April 10, 2024

We have received the following plans for the Edward Rose Project on the Ward Property at the southeast corner of Weber Road and 135th street:

We have reviewed these General Development Plans and offer the following comments.

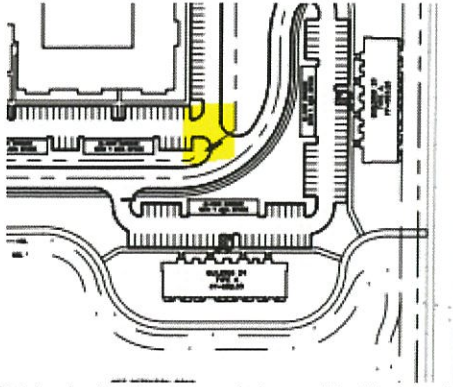
4. Elevations.
 - a. A detail of the proposed dumpster enclosures, garage buildings, clubhouse, and any other outbuildings should be shown on the elevations. **Comment partially addressed: based on the prominence of the detached garages, please increase the height of the brick knee wall. Also ensure foundation landscape is placed around all accessory structures. It appears the mail kiosk was not included.**

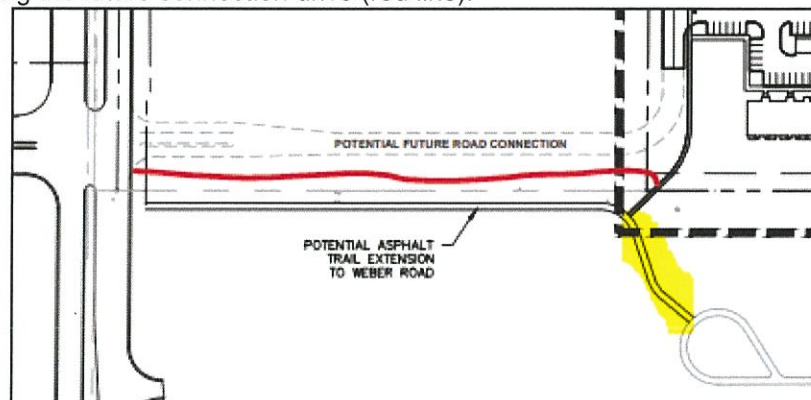
1.11. The sidewalk at the south end needs to be extended into the ComEd property and be attached to the existing multi-use path located there. The applicant can coordinate with ComEd for the section that runs south from their parcel (highlighted yellow). The part that runs to Weber would be along the future connection drive (red line).

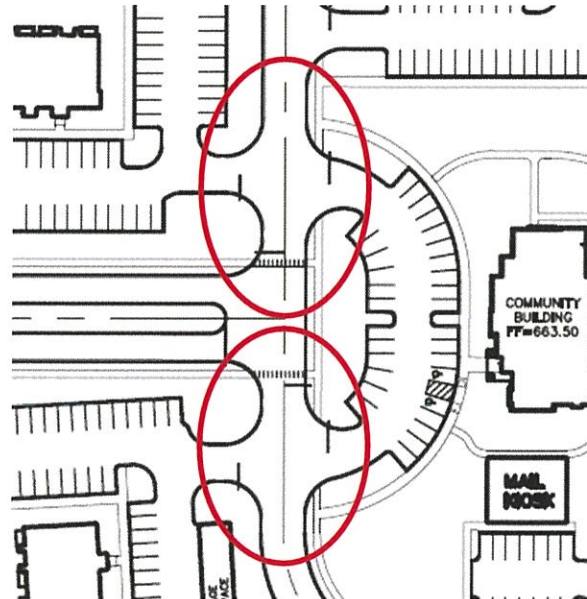
- Village would still like the offsite sidewalk connection to the south with the new business park. Village acknowledges it needs to have discussions with Will County to determine if this is included in the road widening project and Com Ed to see if the sidewalk will be allowed along the Com Ed frontage. The Village believes this to be a relatively minor issue that can be worked out as we move forward.

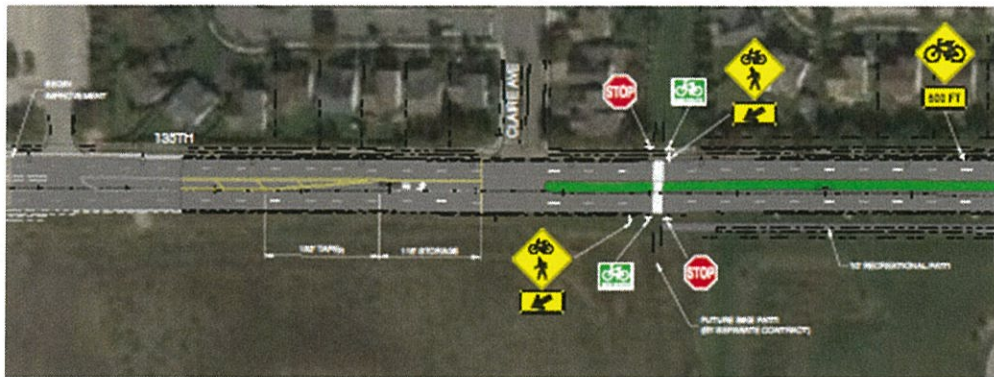
- 1.12. No longer applicable as the site design has been changed to address this.
- 1.13. **Conditionally Compliant** - The main internal intersection that is the 3-way off of Weber should be stop-controlled at all three approaches – there is a lot going on at this location with respect to pedestrians and the community building (plus its access points).
- **While the new configuration adds stop control, the now-aligned driveways add to the congestion by bringing cars exiting the parking lot closer to the intersection. As this will be private, we will not take exception to it if that is what the applicant chooses to do.**
